FAQ Log 11/17/05

FAQ 54.1

FAQ 55.1

FAQ 55.2

Browns Ferry Unit 1/Unit 2 safety-related 4160 electrical distribution single line

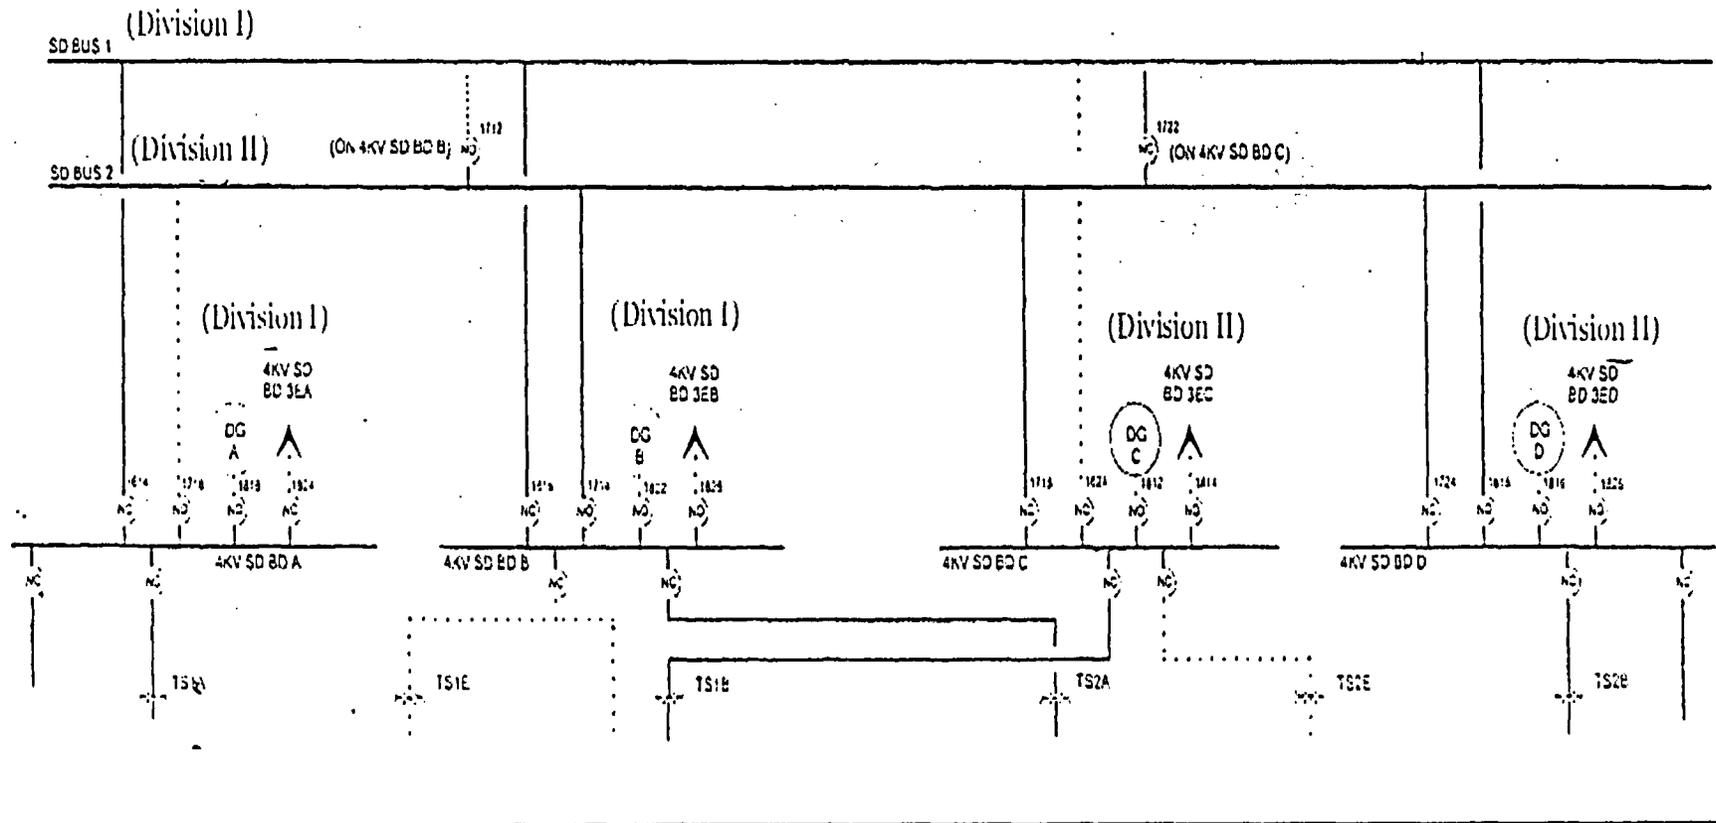
Browns Ferry Unit 1 is being recovered from an extended shutdown. Recovery efforts include replacement of cables to the Division I and Division II Emergency AC (EAC) power. The cables are being replaced in order to provide qualified cables (including requisite documentation) to meet current Environmental Qualification, Post Accident Monitoring, Voltage Drop/Ampacity/Short Circuit requirements, Appendix R, Electrical Separation and to address breakage as identified by electrical calculations.

The Division I and Division II EAC for Units 1 and 2 each contain 2 Emergency Diesel Generators and 2 4160v Shutdown Boards with each Emergency Diesel Generator and Shutdown Board supplying approximately 50% of the emergency power required for each Division EAC. The Emergency Diesel Generators and Shutdown Board are paired as A & B in Division I and C & D in Division II.

To replace these cables, Emergency Diesel Generators A, B, and D and 4160v Shutdown Boards A, B and D will be removed from service one train at a time. The work is planned such that when

A Emergency Diesel Generator and 4160v Shutdown Board A are out of service, the B, C, and D Emergency Diesel Generators and B, C, and D 4160v Shutdown Boards will remain available. Also when the B or D train is out of service the other three trains will remain available. The work to replace the cables on any one of the trains can be done within the Tech Spec AOT of 14 days for the Emergency Diesel Generator.

The effect of the Browns Ferry Nuclear (BFN) Unit 1 Emergency AC (EAC) power restoration activities on Unit 2 and Unit 3 system unavailabilities is a unique condition that had not been anticipated during the development of the PI guidance document. The unavailability of the Unit 2 and Unit 3 systems due to the Unit 1 EAC restoration work does not truly reflect the performance of the Unit 2 and Unit 3 systems. For this unique, one-time-only activity, the planned BFN Unit 1 EAC restoration may be treated similar to "Planned Overhaul Maintenance." That is, if additional time is needed beyond the original schedule duration to repair equipment problems discovered during the restoration activities, the additional hours would count toward the indicator. In addition, other activities may be performed with the restoration activity as long as the outage duration is bounded by the restoration activities. If the restoration activities are complete, and the outage continues due to non-restoration activities, the additional hours would count toward the indicator.
